APPLICATION FOR PERMIT TO DRILL OR REENTER

2. Name of Operator Cimarex Energy Co. of Colorado		7. If Unit or CA Agreement, Name and No. Pending
3a. Address PO Box 140907 Irving, TX 75014		8. Lease Name and Well No Yoshi 5 Federal Com No. 1
3b. Phone No. (include area code) 972-401-3111		9. API Well No. 30-015- 31852
4 Location of Well (Report location clearly and in accordance with any State requirements.)* At Surface 2280 FSL & 330 FWL 1650' FSL & 330' FWL At proposed prod. Zone 2280 FSL & 330 FSL 1650' FSL & 330' FEL C.D. 10/7/08 7/08 7S-29E		10 Field and Pool, or Exploratory Empire; Glorieta-Yeso Wildcat

SUNDRY NOTICES AND REPORTS ON WELLS
Do not use this form for proposals to drill or to re-enter an abandoned well. Use form 3160-3 (APD) for such proposals.

Per BLM request to avoid playas, Cimarex has moved the SHL for the Yoshi 5 Federal Com No. 1 as shown below:

WELL LOCATION AND ACREAGE DEDICATION PLAT

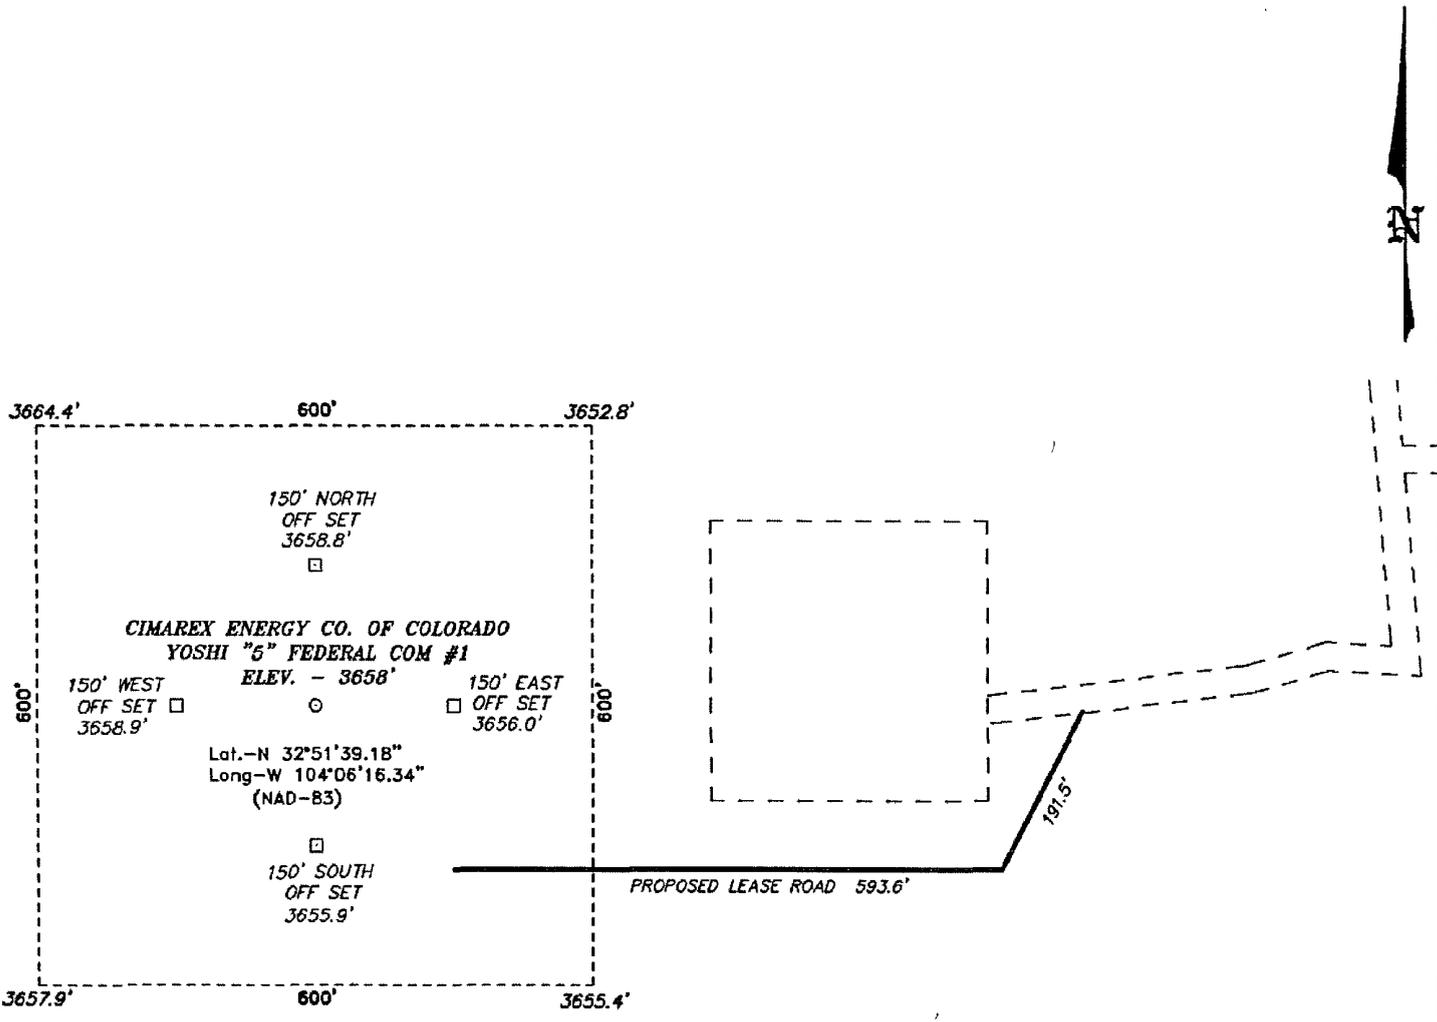
Previous Location 5-17S-29E SHL 2280 FSL & 330 FWL BHL 2280 FSL & 330 FEL	New Location 5-17S-29E SHL 1650 FSL & 330 FWL BHL 1650 FSL & 330 FEL
--	---

The new access road is all on-lease and will not require a ROW.
Please see attached revised plats and preliminary directional survey.
